Atherton Hospital Redevelopment

MAIL TYPE	MAIL NUMBER	REFERENCE NUMBER
Response to RFI	PTA 1-RTRFI-001953	FKG-RFI-001227

Re: URGENT - Level 1 Rectification Alternative

File Name
 SK1001_Level 1 Rectification detail.pdf

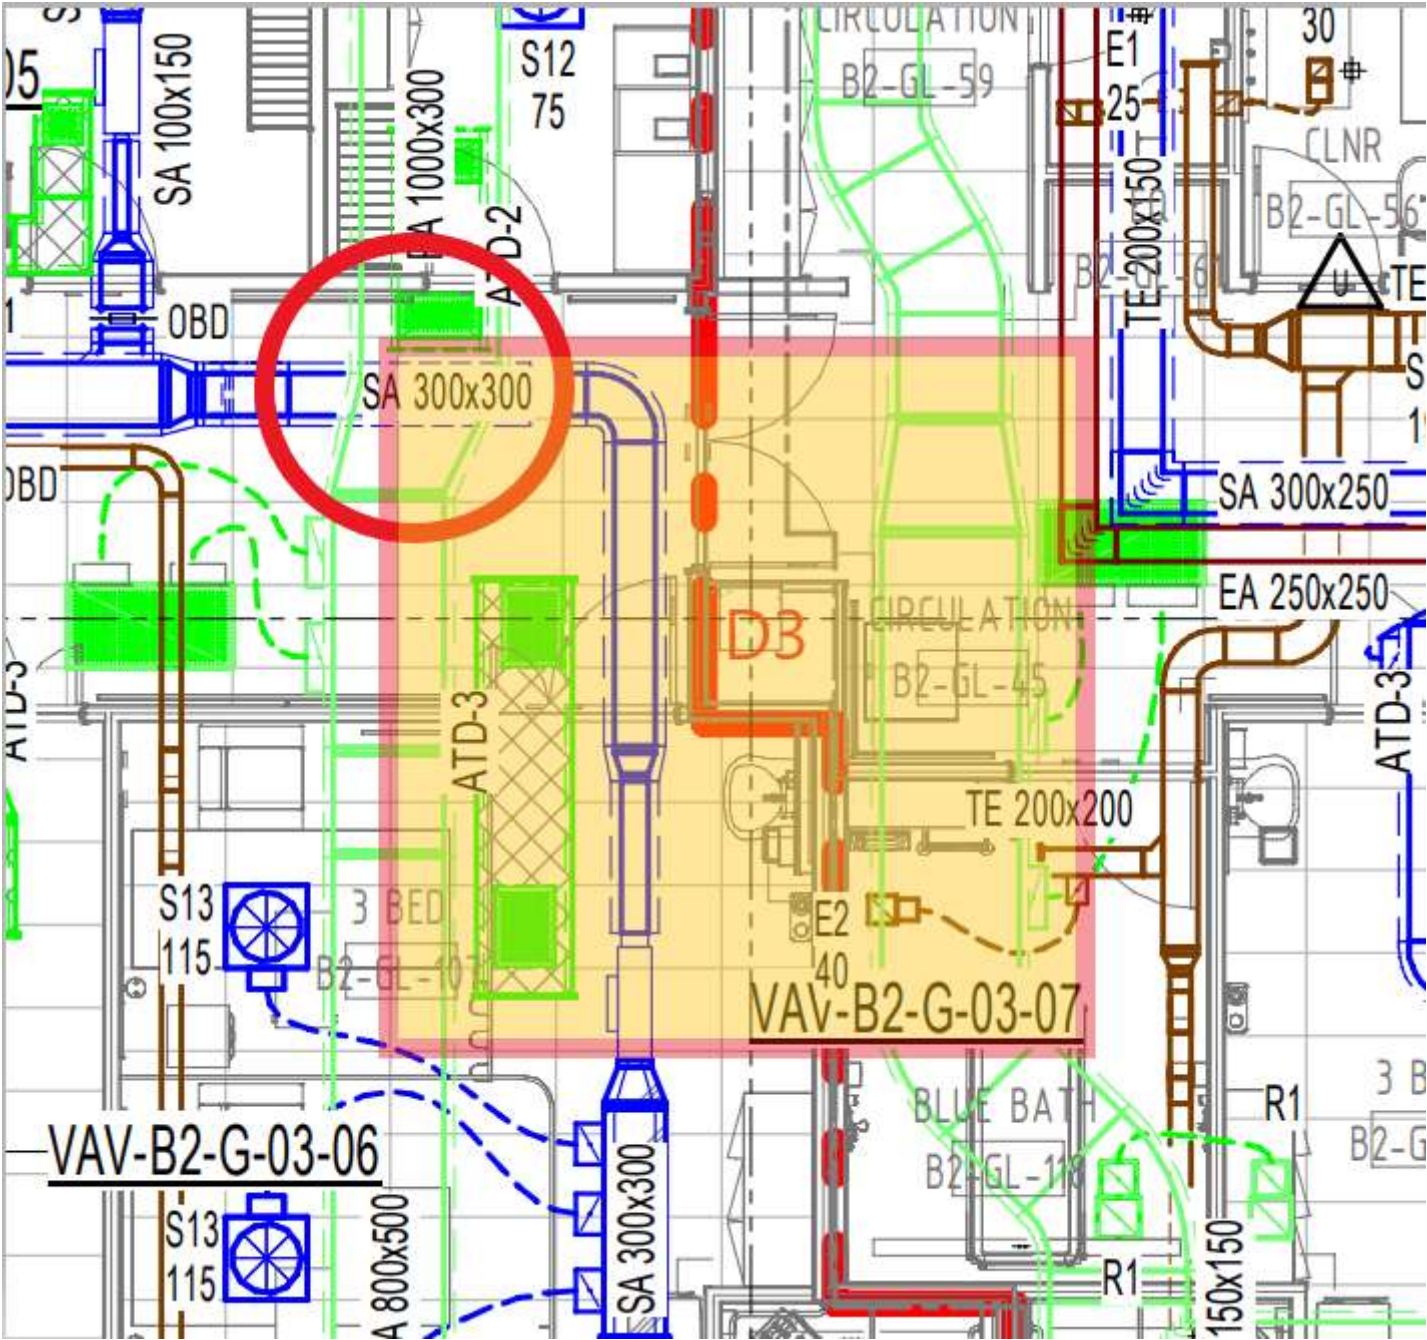
I believe you have already received this rectification detail from GHD. However please see attached concept slab rectification detail for consideration and discussion before it is formally issued.

We note that it will have a minor clash with some of the mechanical ductwork shown circled below.

However we anticipate that this will be coordinated between yourselves and VAE?

See attached alteranativbe rectification detail for the Level 1 column at D3. We have been assued this will provide the equivalent moment capacity and exceed the sheer capacity required in this location.

We request this be reviewed and acceptance be provided as a matter of urgency, we wish to begin these works immediately.
